FROM: Kirk A Bowers, PE
Mountain Valley Watch

DATE: February 16, 2021

SUBJ: Mountain Valley Pipeline Slip report analysis, milepost 57.2-57.3

Soils map for section of MVP at Milepost 57.2

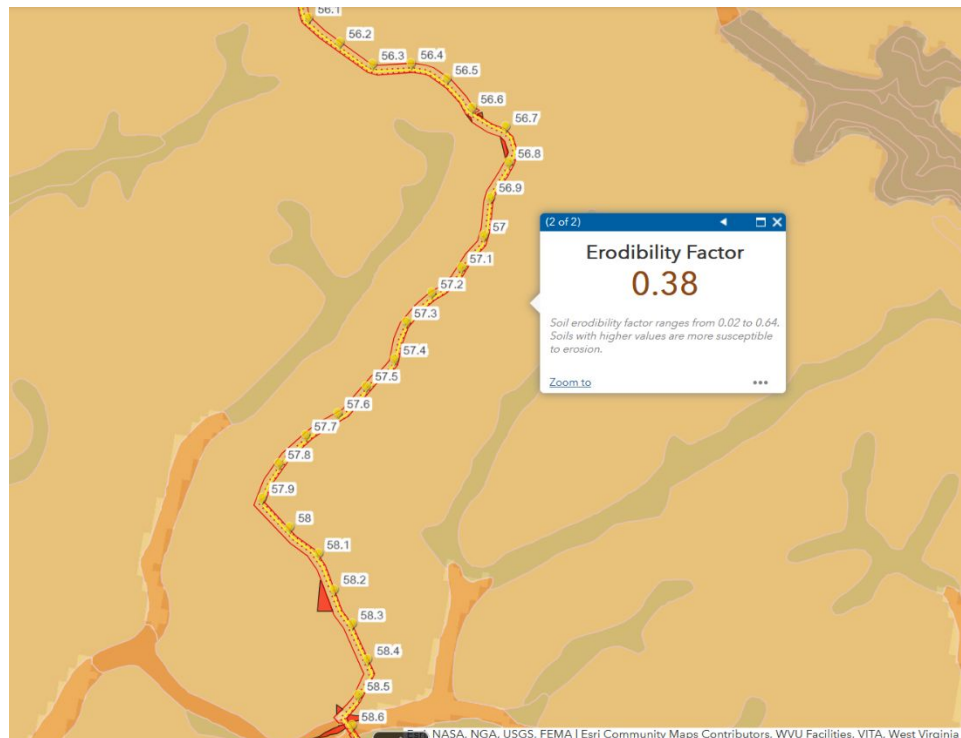
Dominant soil Erodibility Factor, $K_f = 0.38$

Chapter 6, VA Erosion and Sediment Control Handbook, p. IV-44 (shown below) includes an explanation of the Erodibility factor and lists three groups of erosion hazard. **K_f factors above 0.36 are documented high risk No Build Zones.**

December 2020 Milepost 57.2

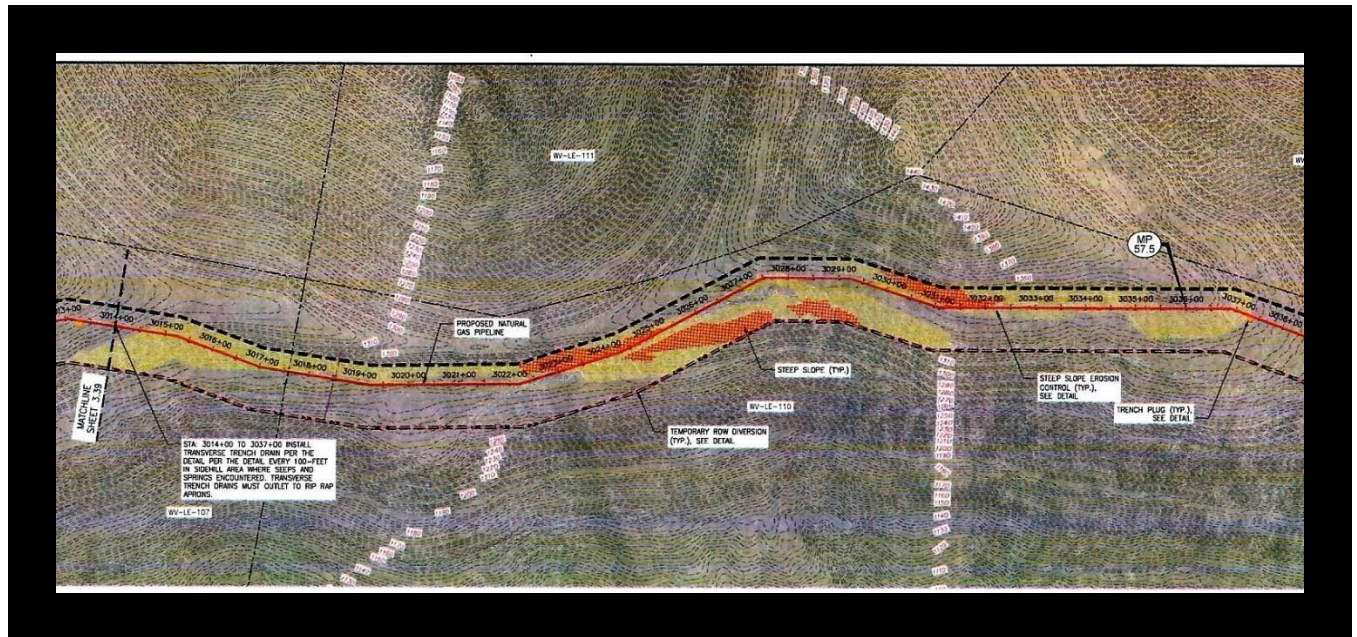
The photo below is from a recent aerial flight over the MVP that records construction in the ROW. The photo is in the area of recent landslides. What appears like a "construction site" in the photo below of MP 57.2 is a remediation effort for the location where the installed pipeline shifted early LAST year and was not adequately stabilized.

Construction plan sheet 3.40 showing location of landslide

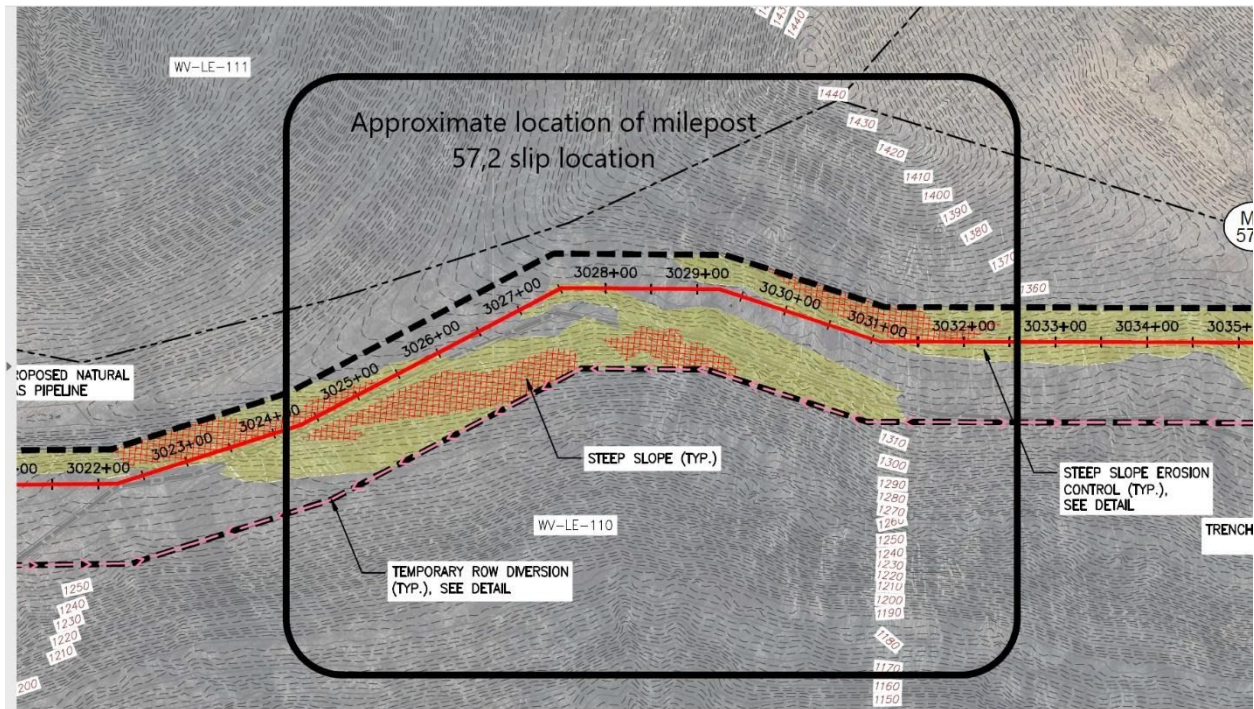
The pipeline at milepost 57.2 is located on the side of a mountain. Elevation differences above the pipeline centerline are dependent on location. The lowest elevation difference is 8 feet at Station 3026+00. The highest elevation difference is 80 feet at Station 3030+00.

Higher elevation differentials on the slope of a mountainside creates a large mass of overburden which produces a downward force on the existing pipeline and displaced soils. The slopes below the pipeline are steep and provide little stability for sliding soils.

The ridgeline elevation shown on the MVP construction plan sheet 3.40 shows a large difference in elevation on the side of a steep mountain slope. There is up to 80 feet of elevation difference shown on the construction plan. The soils in this area are extremely sensitive to erodibility as indicated by a K_r , erodibility factor, of 0.38. This is a high slip hazard area and construction was not recommended or suitable at this location.

What method was used to stabilize this area from further soil displacement? What guarantees are there that the pipeline in this area will not rupture during future landslides?
